Re: Danville Wastewater Treatment Facility Preliminary Engineering Report
60% DEC Comments Response

Below please find a summary of the comments provided on the Danville Wastewater Treatment Facility 60% Preliminary Engineering Report and the responses.

Figure 2-6: Effluent pH

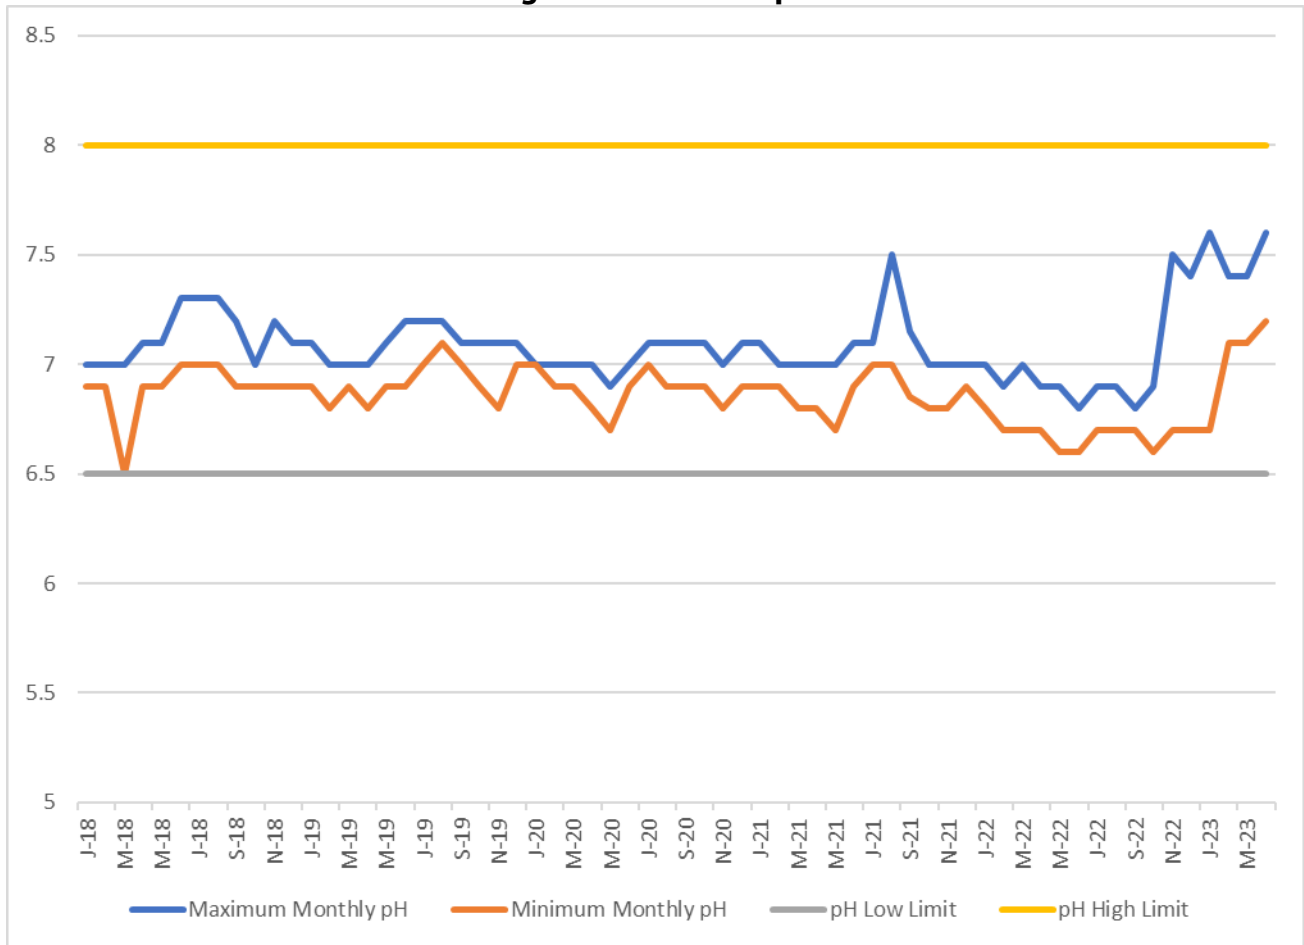
Is there a change in operations or chemicals that can explain the latest higher value?

This change was due to a temporary change in operations with new staff on-site and need to adjust aeration blower speed.
